ADDENDUM NO. 2

SUBJECT: **CENTAL WASTEWATER TREATMENT PLANT DEMOLITION PROJECT**
CITY-PARISH PROJECT NO. 14-TP-MS-016D

MAP SHOWING BOUNDARY SURVEY OF
21.3362 ACRE TRACT
AND DEDICATION OF
25' SANITARY SEWER SERVITUDE
SUBURB SOUTH BATON ROUGE
GREENSBURG LAND DISTRICT OF LOUISIANA,
PARISH OF EAST BATON ROUGE, LOUISIANA
CITY OF BATON ROUGE
FOR
EAST BATON ROUGE PARISH

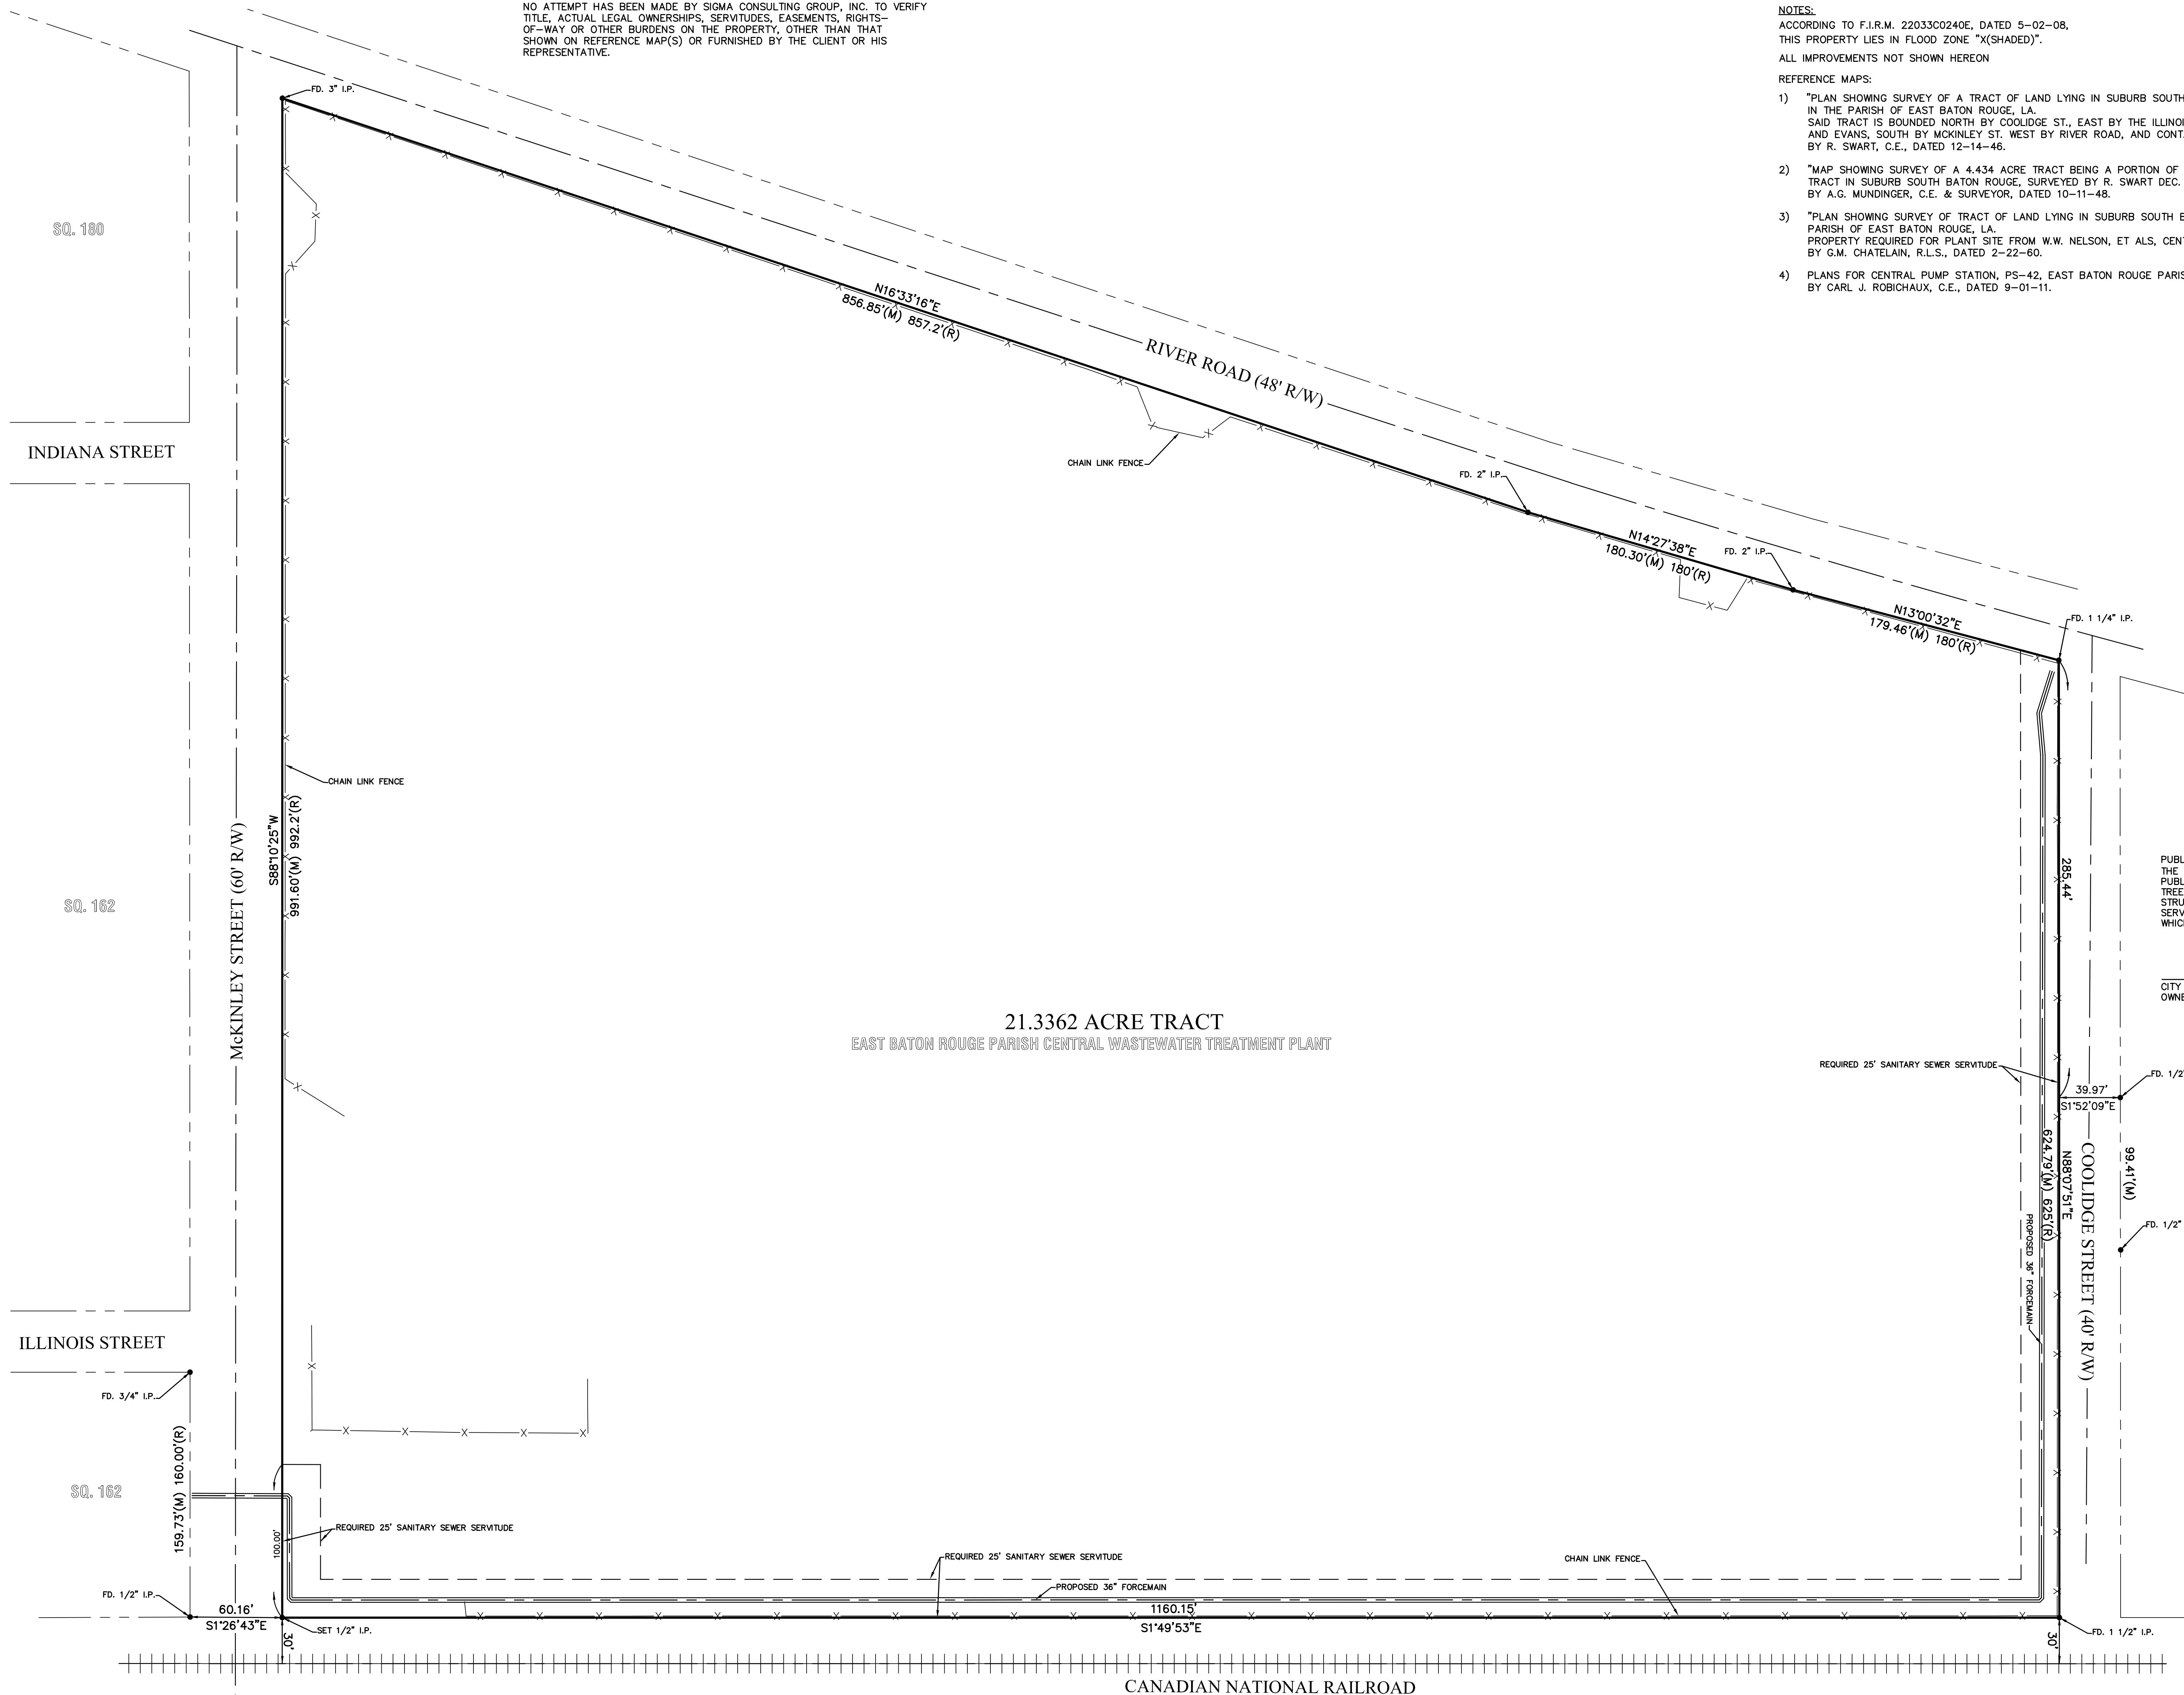
4. Is there a live force main onsite? If so, where is it located and what direction does it run?

Yes, see attached exhibit showing the approximate location of the live forcemain.

MECHANICAL UPPER PLAN

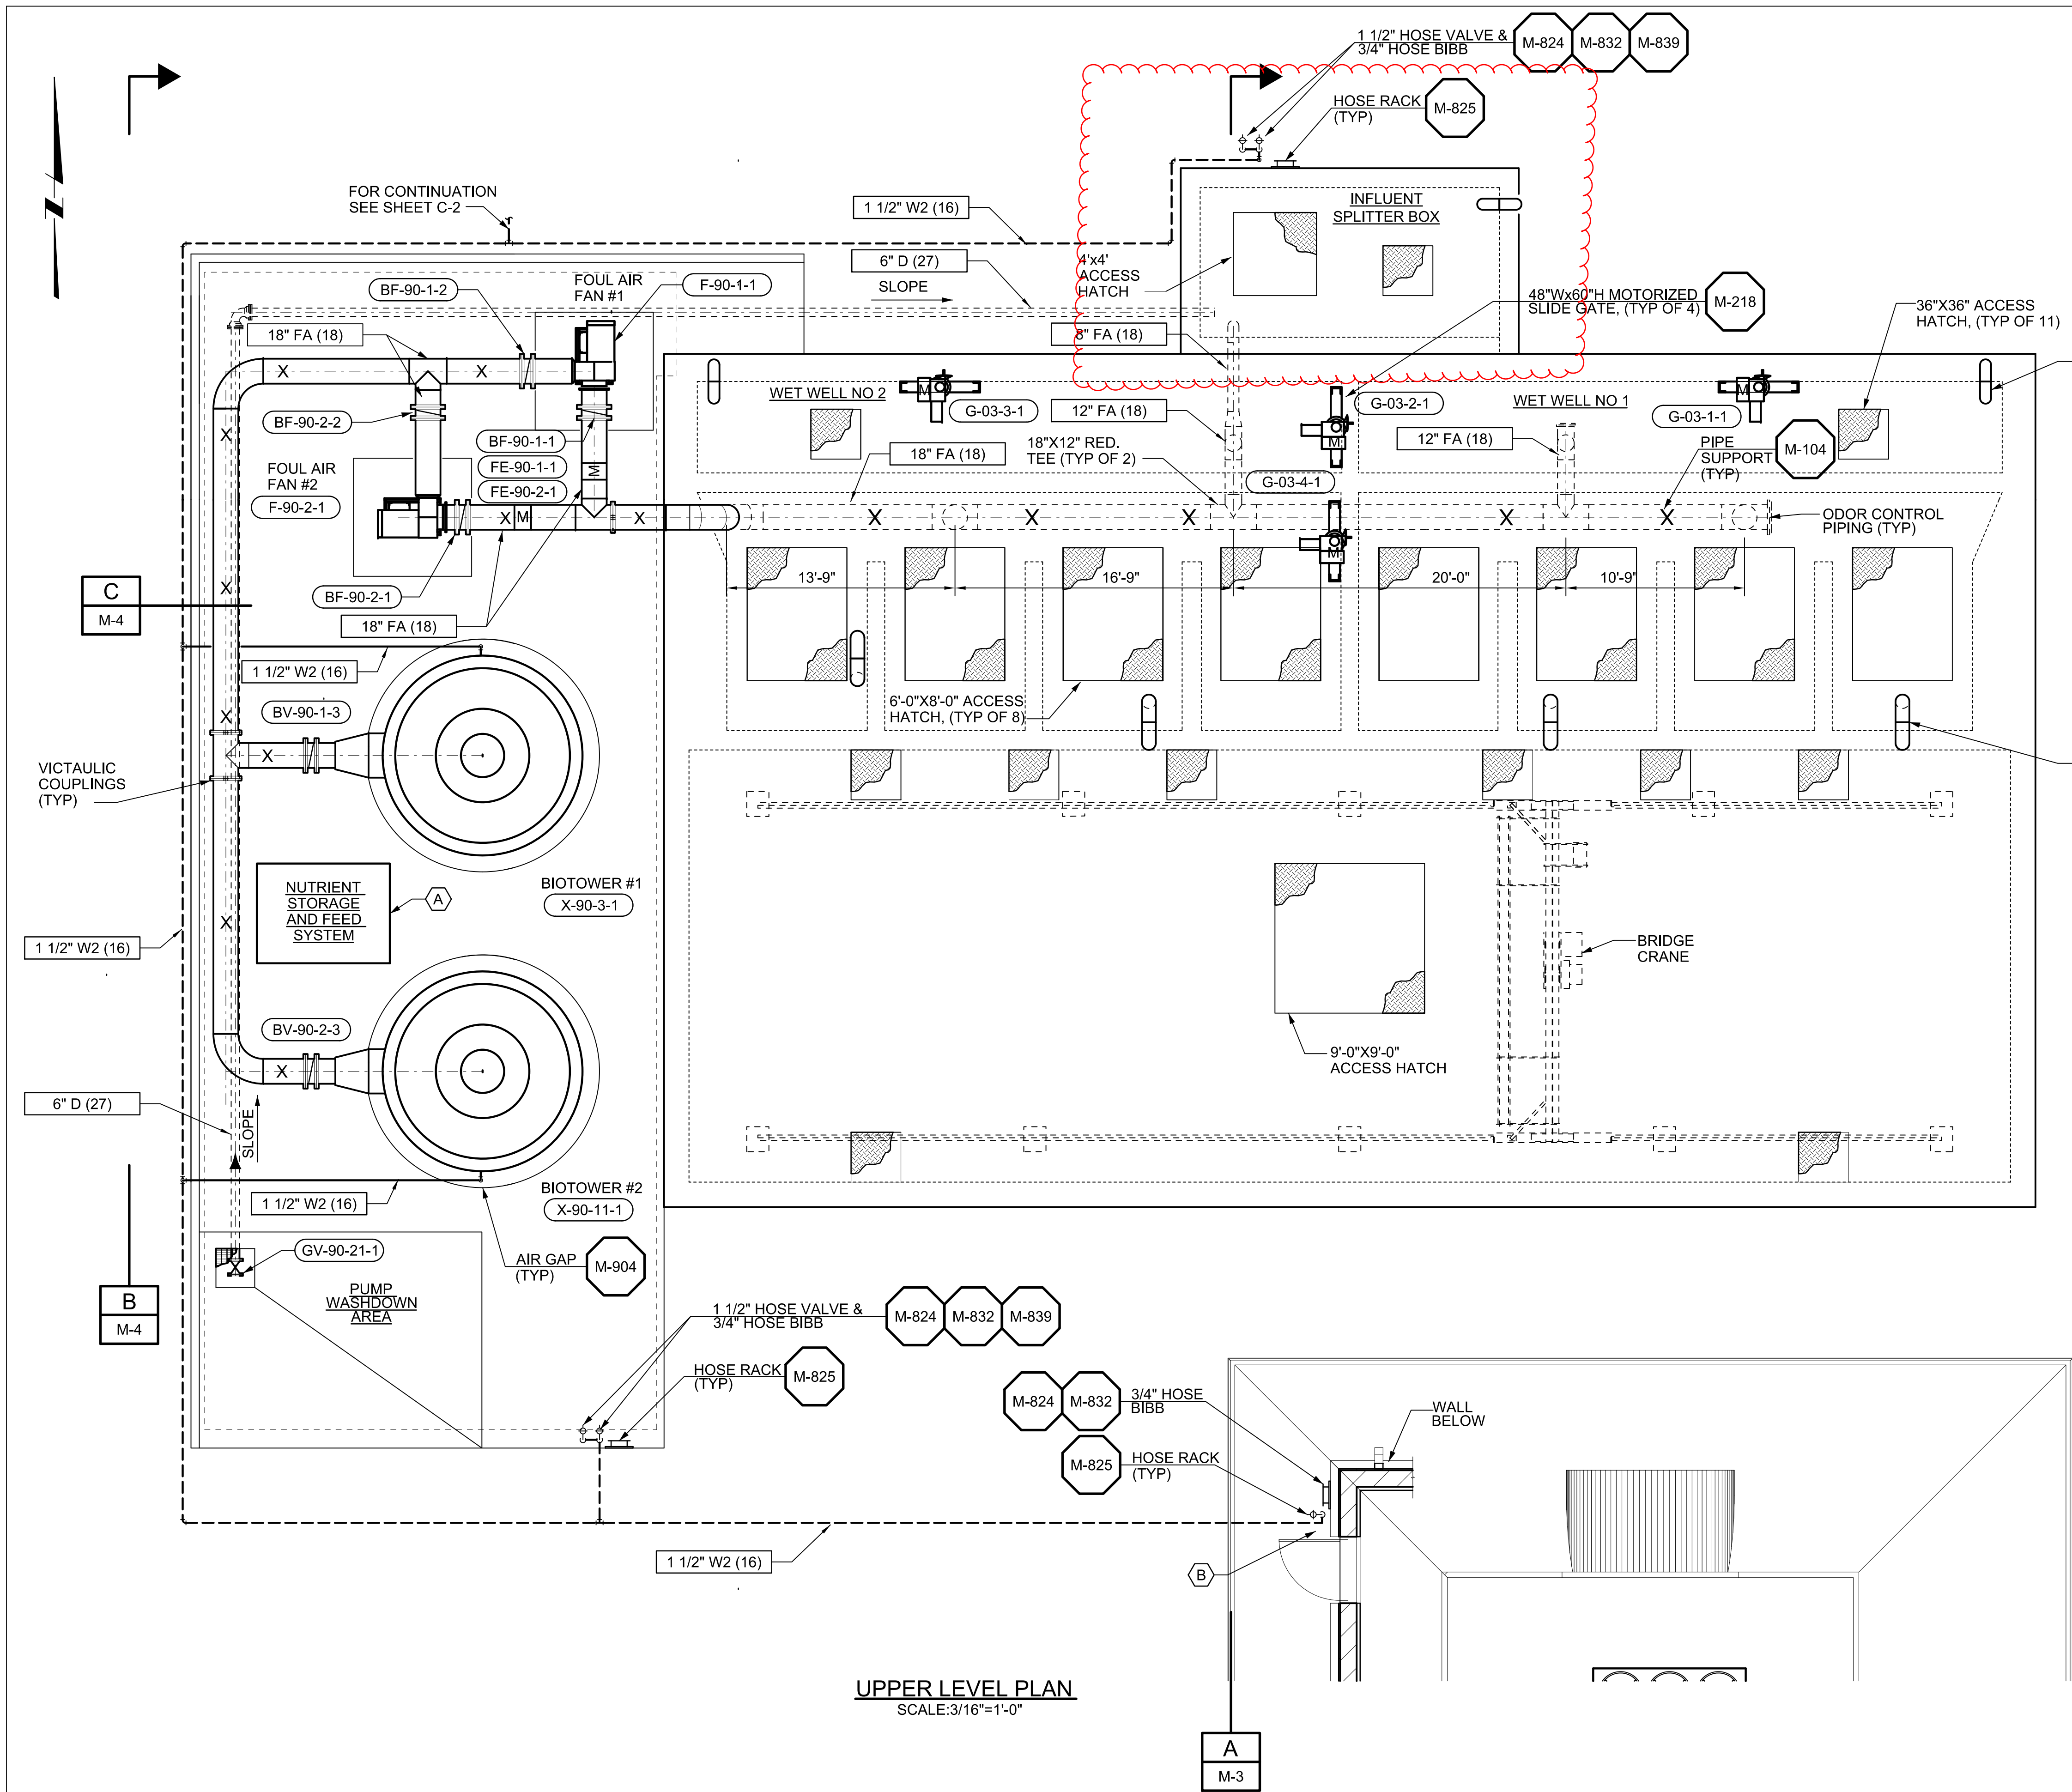
1. We need to know the location of the manhole to pump the water to get the water to the new treatment plant

Contents to be pumped across the street to PS 42 influent splitter box. See attached mechanical plan sheet. The PS 42 site is located at 1045 W McKinley St, and the site will be made accessible to the Contractor during construction. Provisions shall be made by the Contractor such that no road closures are required for bypass pumping.
